Municipal Planning Commission
Regular Meeting

Minutes

June 13, 2024
4:00 PM

2024-MPC-13 : HEARTLAND COMMERCE PARK MASTER SIGN PLAN

SIGN B- LOT 7

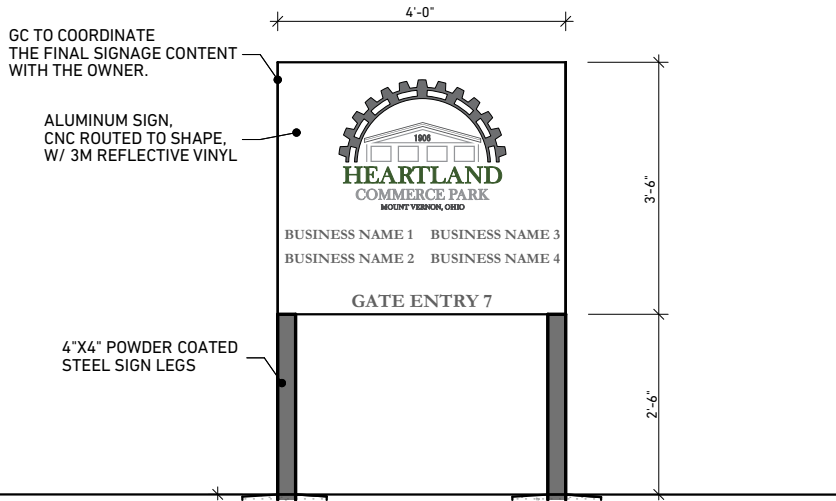
Hawkins asked about Sign B, Lot 7 with different business names included, if it is up to the HOA to update those names as businesses turn over. Gottke said yes.

SIGN D- PEDESTRIAN ENTRY

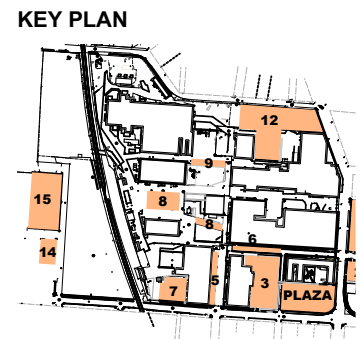
Gottke (sworn in) explained the Comprehensive Development Plan (CDP) for this PCDD property known as Heartland Commerce Park was approved a year or more ago, then an amended plat was approved recently. A sign plan was not included in the original CDP or declarations. The parking lots are being refurbished. The corner area at Sandusky and Chestnut Streets will become an employee plaza, an outdoor work/break area. The sign plan being proposed is for the property. It does not include building signage because those are interior to the property and not visible from a public street. The signage proposed in this package is more for directional guidance, and HCP as a whole, not the individual businesses. There are no sign rules for a PCDD property. They looked at the existing sign code for other districts and what exists at the Industrial Park to create a sign plan for this complex. A low wall is planned for the Sandusky/Chestnut corner near the employee plaza, with Heartland Commerce Park branded signage in addition to individual company name signs, sort of like the entrance to the Industrial Park. The company signs will be the same size as those at the Industrial Park Entrance located on State Route 13 and Commerce Drive. ADF maintains the entrance sign as the Industrial Park. Further west on Chestnut Street a perpendicular sign is proposed for sign A, Lot 7. The height is proposed at 10' to allow for visibility if an automobile is parked beside it. This is the main entrance to the complex. The pedestrian entry on Sandusky Street, across from Sugar Street has a black metal arched sign on brick pillars planned. There are removable bollards planned to block vehicle traffic. The City Engineer asked if a fire truck would fit under the arched sign. The measurements provided make it appear that a fire truck would not fit.

Hawkins asked about making approval contingent upon confirmation that a fire truck could enter through the pedestrian arch sign. Broeren suggested allowing Ms. Blankenhorn to change the height for that without changing the design to ensure a fire truck will clear, if the fire department so desires.
